February 6, 2015

Re: The Buzzards Bay Coalition's Comments on the Draft NPDES No. MA 0100030 for the Town of Marion Water Pollution Control Facility

Figure 1. Coalition water quality monitoring data for Aucoot Cove at stations AC7 and AC2.

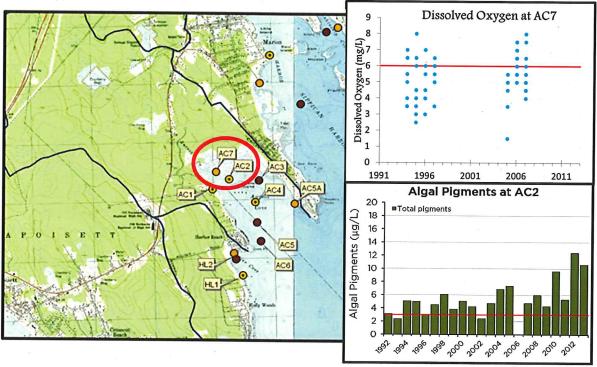
Coalition data illustrate that Aucoot Cove and Sippican Harbor are beyond their ability to assimilate current nitrogen discharges.<sup>4</sup> Figure 1 shows that Aucoot Cove falls short of the state dissolved oxygen numeric criteria of 6.0 mg/L a majority of the time. These data also show degraded water quality due to the excessive amounts of chlorophyll in the water column violating the aesthetic value requirements of the SWQS.

Figure 2. Coalition water quality monitoring data in Sippican Harbor at monitoring station SH1.

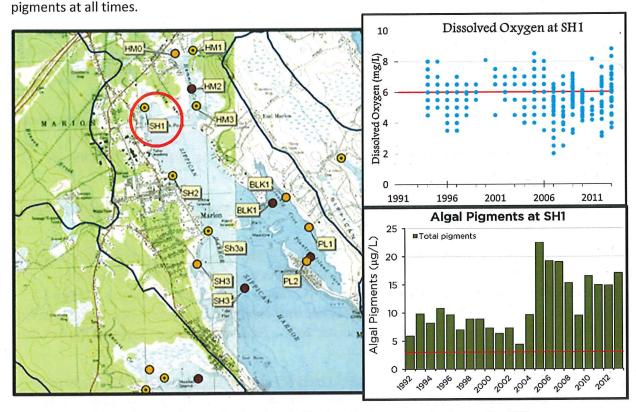
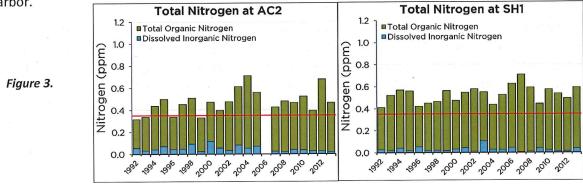
Figure 2 illustrates the same condition in Sippican Harbor which also fails to satisfy the minimum state dissolved oxygen numeric criteria a majority of the time and exceeds the maximum amount of algal
